Access Compliance Report

Public Rights-of-Way

Intersection ID: 10917	Main Street: E_25TH_ST	Cross Street: N_DAVIDSON_ST	Location: W
ADA ID: 779F398139DD	Ramp Type: Directional1	Initial Pass/Fail: Fail	Overall Compliance: No
			Severity Score: 46.25

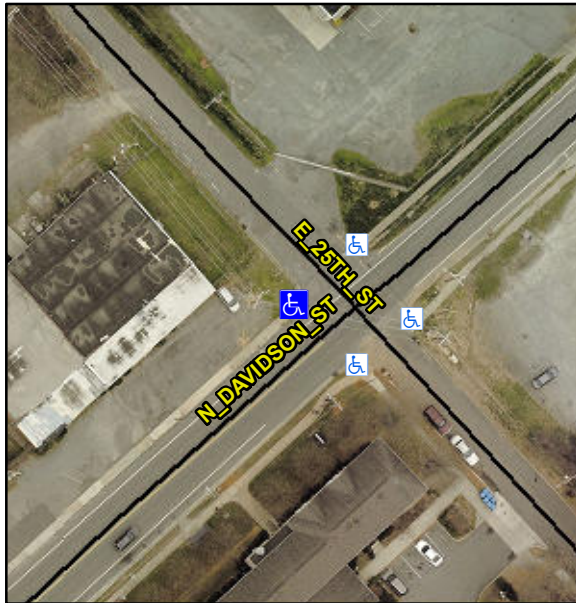
R304.5.1, R304.2.2, R304.5.3

Compliance	Description	Data	Compliance	Description	Data
N/A	Ramp Length (in)	105.0	N/A	Grade Break?	N/A
No	Ramp Width (in)	40.0	N/A	Grade Break Slope (%)	0.0
No	Ramp Slope (%)	10.4	N/A	Grade Break XSlope (%)	0.0
No	Ramp XSlope (%)	7.9			
N/A	Flare Type LT	N/A	N/A	Flare Type RT	N/A
N/A	Flare Slope LT (%)	N/A	N/A	Flare Slope RT (%)	0.0
N/A	Flare Traversable LT?	N/A	N/A	Flare Traversable RT?	N/A
N/A	Landing Length (in)	0.0	N/A	DWS Provided?	N/A
N/A	Landing Width (in)	0.0	N/A	DWS Contrast?	N/A
N/A	Landing Slope (%)	0.0	N/A	DWS Length (in)	N/A
N/A	Landing X Slope (%)	0.0	N/A	DWS Full Width?	N/A
N/A	Landing Curb? (Y/N)	N/A	N/A	DWS Offset LT (in)	N/A
N/A	Shared Landing?	N/A	N/A	DWS Offset RT (in)	N/A
N/A	Gutter Ponding?	0.0	N/A	Gutter Slope (%)	N/A
N/A	Gutter Lip Ht (in)	0.0	N/A	Gutter X Slope (%)	N/A
N/A	Painted X Walk1?	No		Road Slope (%)	1.4
	X Walk 1 Direction	To NE		Road X Slope (%)	6.4
	X Walk 1 Width (in)	N/A		Clear Space?	N/A

Remove & Replace Entire Ramp.
